ZONING CHANGE REVIEW SHEET

CASE: C814-2018-0121 -- 218 South Lamar

TO: PUD

ADDRESS: 218 South Lamar Boulevard Southbound

4-Lane Divided, 60' Curb-to-Curb
Back-of-Curb Condition F
Barton Springs Road to Riverside Drive

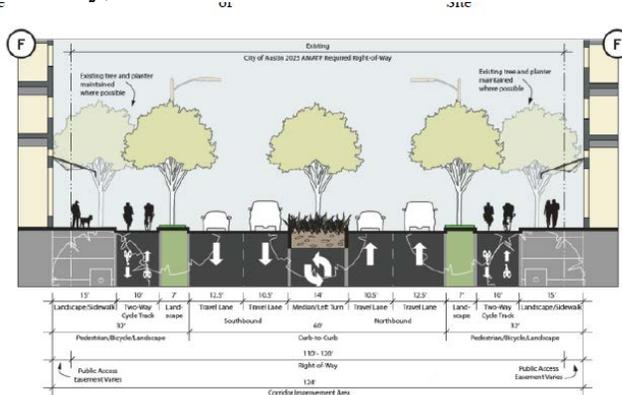
TR2. Include the below streetscape in the land use plan. Contact this reviewer for a more legible copy of it if necessary. This project is adjacent to a street that has been identified in Austin’s Corridor Mobility Program (S Lamar). The sidewalk and bicycle facilities shall comply with the required cross-section at the time of the site plan application. The cross section that will be required is shown below. Find additional information about the Corridor Mobility Program here: <https://data.austintexas.gov/stories/s/Corridor-Mobility-Program/gukj-e8fh/>. Any proposed curb relocations on S Lamar requires coordination with the Corridor Planning Office and Bicycle Program. The cross section will include a 7’ planting zone with street trees, a 10’ two-way cycle track, and a 15’ clear zone all behind curb. Additionally, a protected intersection will be required at Toomey, to be reviewed at the time of Site Plan.

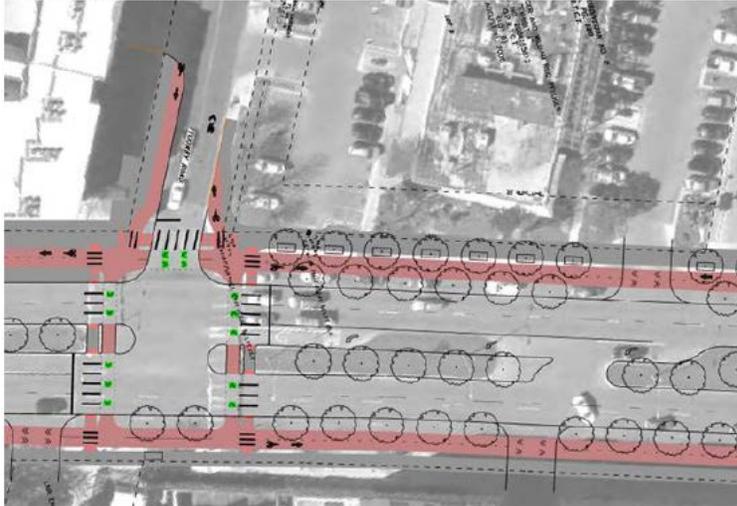
TR5. Bicycle facilities will be required along Toomey Road at the site plan stage. The design is below. Include the below graphic on the land use plan. If a more readable copy is required, contact this reviewer.
